**CONTINUING ELIGIBILITY INSPECTION (CEI) REPORT**  
*FOR HURRICANE & SHORE PROTECTION PROJECTS*

1. Project Name: Saipan Beach Road SPP
2. Date of Inspection: February 8, 2002
3. Inspection Personnel:

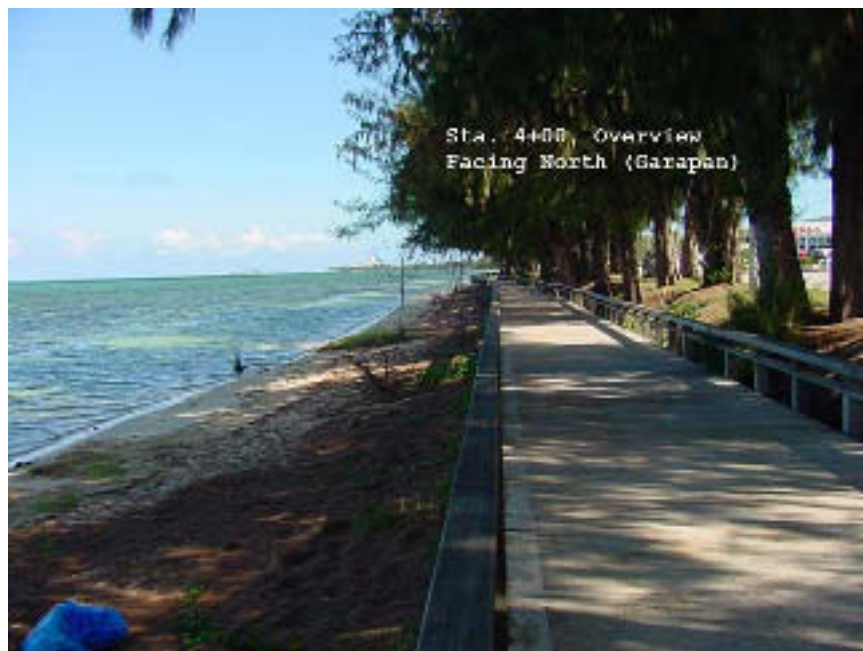
- a. Sta. 0+00, Overview facing North, no action required.

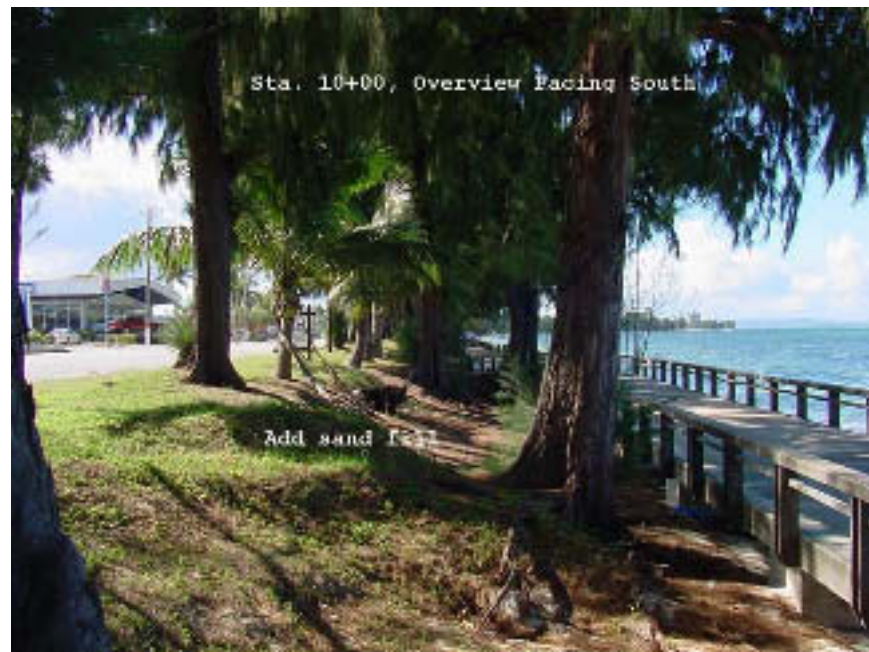
h. Sta. 7+00, replenish eroded sand fill.
